Ref: SSD-82548708

**RESPONSE TO SUBMISSIONS SSD-82548708, RESIDENTIAL FLAT BUILDING WITH
INFILL - 24, 26 & 28 MIDDLE HARBOUR ROAD, LINDFIELD**

Attachment 1 - Ku-ring-gai Council's Response to Applicant's RTS

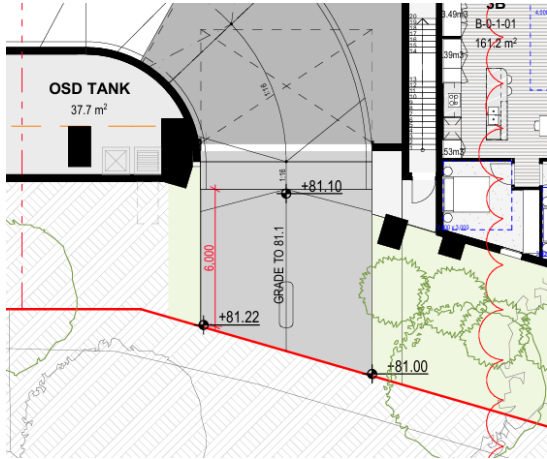
Unacceptable Streetscape and Amenity Impact	Unresolved. Objective 4O-2 Landscape design contributes to the streetscape and amenity inconsistencies The removal and loss of mature and significant trees (for example Trees 1 and 18) that contribute positively to the established streetscape and desired future landscape character, of high significance in good health and condition fails to contribute to the streetscape and amenity and is inconsistent with ADG Objective Part 4O-2 and design guidance. The removal of trees 1 and 18 and impacts to trees 9, 15, 16 and 37 fails to adequately consider landscape amenity that the trees provide and the urban forest that characterises Ku-ring-gai. There is design opportunity with increased development setback to enable the viable retention of trees: 1, 9, 15, 16 and 18 (high significance) and other trees (37) that contribute to the established landscape and streetscape character. Development setbacks shall be increased to enable their viable retention. Stormwater / landscape conflicts

The location of the proposed OSD tank outside of the basement footprint within landscape setbacks fails to adequately consider the impacts for the ability of the proposal to provide deep soil landscape zone for the planting of trees to contribute positively to the landscape character. The OSD tank location should be reconsidered and relocated within the building footprint and outside of boundary setbacks. The location of drainage infrastructure and pits fails to adequately consider retained trees of high significance and retention value that form part of a critically endangered plant community. The provision of a rock lined drainage swale across the site frontage fails to provide sufficient plantings including tall trees to contribute positively to the streetscape and resident and neighbour amenity and therefore fails Part 4O-2 Objective.
Unacceptable Tree Removal and Impacts	Unresolved. Tree removal and impacts KDCP Part 13 Tree and Vegetation Preservation The removal and impact to trees: 1, 9, 11, 15, 16, 18 and 37 fails to protect and maintain the established treed landscape character and is inconsistent with the aims, objectives and controls of the DCP. The arboricultural impact assessment report has down graded the significance value of tree 18 Syncarpia glomulifera (Turpentine) from high to low when the trees health and stature has not changed. It appears this is done to facilitate development over environmental considerations. The tree is an endemic tree mapped as part of a critically endangered plant community (Sydney Turpentine Ironbark Forest / STIF). The tree at 24m high is visually significant and contributes positively to the established landscape and treed character. The project arborist within part 4, page 16 has stated: <i>'Mature native trees located in the northeast boundary adjacent to existing buildings, appear in good form and vigour. However, Root Mapping Investigation report has found large woody root, Pruning Specification has revealed a large amount of canopy to be removed. It is recommended that Tree 18 is removed, the presence of significant roots within the Tree Protection Zone (TPZ), the loss of canopy exceeding 10%, causing increased risk of decay and structural weakness, reduced tree health, longevity, and amenity value.'</i> <i>Tree 18 indicates that construction or excavation in these areas may adversely impact the health, stability, or longevity of the subject tree. Where roots were located beneath existing structures, there is potential for future structural conflict. Tree will endure an unsustainable impact from the proposed building'.</i> The project arborist has recommended tree 18 be removed based purely on root conflict. Given the trees ecological value as part of a critically endangered plant community and its high significance within the broader landscape, the proposal should be amended to demonstrate avoidance of impact. In this regard the proposal shall be amended to ensure no greater than a 10% encroachment within the notional root zone / tree protection zone when assessed against AS4970-2025 Tree protection of development sites. <u>The removal of tree 18 is not an acceptable landscape outcome.</u> The impact to and/or removal of trees: 1, 9, 15, 16, 18 and 37 is not an accepted landscape outcome, requiring design modifications to enable their viable retention.
